## SERVICE BULLETIN FAA/DAS APPROVED

NUMBER CSB-99-01  
DATE 7/19/99

SUBJECT: Brush wear in the 1C812-( )-( ) and 1C822-( )-( ) torque sensing pitch servos.

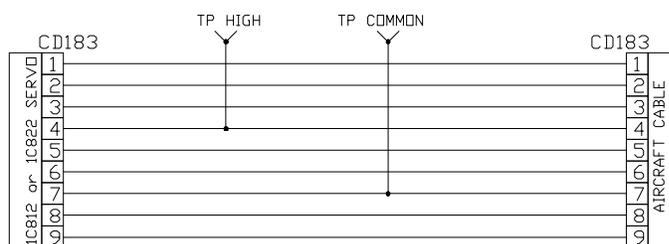
The servo can be tested in the aircraft by field fabricating and inserting a breakout test cable (see below) between the aircraft harness connector designation CD183 and the 1C812 or 1C822 pigtail connector designation CD183 and performing the following procedure.

Connect a digital DC voltmeter set on a scale to accurately read + and - 500 mVDC positive lead to TP High and negative lead to TP Common. Apply power to the Autopilot system and ensure that the voltage to the Autopilot is greater than 11.8 volts for a 14 volt aircraft or 22.5 volts for a 28 volt aircraft. With the Autopilot disengaged observe the DVM and slowly move the elevator or stabilator controls through their full range of travel. The DC voltage indicated on the DVM should at no time throughout the range of the pitch control travel exceed + or - 350 mVDC.

Should the voltage exceed 350 mVDC the servo will have to be replaced. Availability of parts may be obtained through you're Century Flight Systems Authorized Avionics Shop.
